Unit or CA Name: POKER LAKE UNIT

US Well Number: 3001554189

Sundry ID: 2823631

Type of Action: APD Change

WELL LOCATION INFORMATION

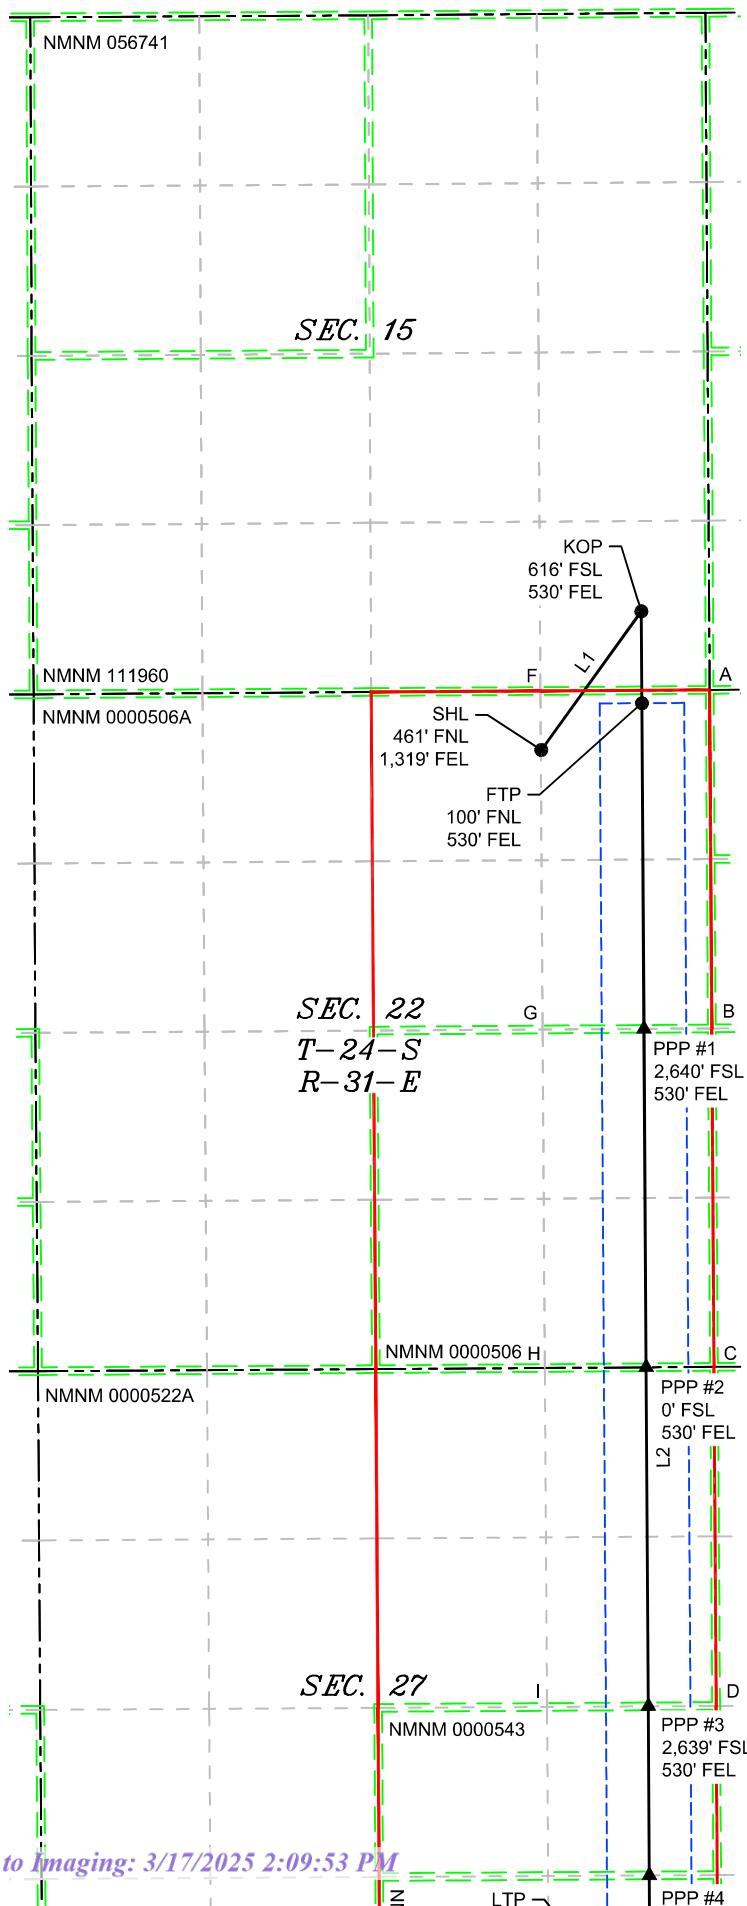
XTO Permian Operating, LLC. respectfully requests approval to make the following changes to the approved APD. Changes to include SHL, KOP, FTP, LTP, BHL, Proposed total Depth, and Pool. There is no new surface disturbance. There is a dedicated change.

FROM: TO:
SHL: 462' FNL & 1169' FEL OF SECTION 22-T24S-R31E 461' FNL & 1319' FEL OF SECTION 22-T24S-R31E
KOP: 462 FNL & 1169 FEL OF SECTION 22-T24S-R31E 616 FSL & 530 FEL OF SECTION 15-T24S-R31E
FTP: 330' FNL & 330' FEL OF SECTION 22-T24S-R31E 100' FNL & 530' FEL OF SECTION 22-T24S-R31E
LTP: 330' FSL & 330' FEL OF SECTION 27-T24S-R31E 100' FSL & 530' FEL OF SECTION 27-T24S-R31E
BHL: 200' FSL & 330' FEL OF SECTION 27-T24S-R31E 50' FSL & 530' FEL OF SECTION 27-T24S-R31E

The proposed total depth is changing from 20806 MD; 10388 TVD to 19919 MD; 8924 TVD.
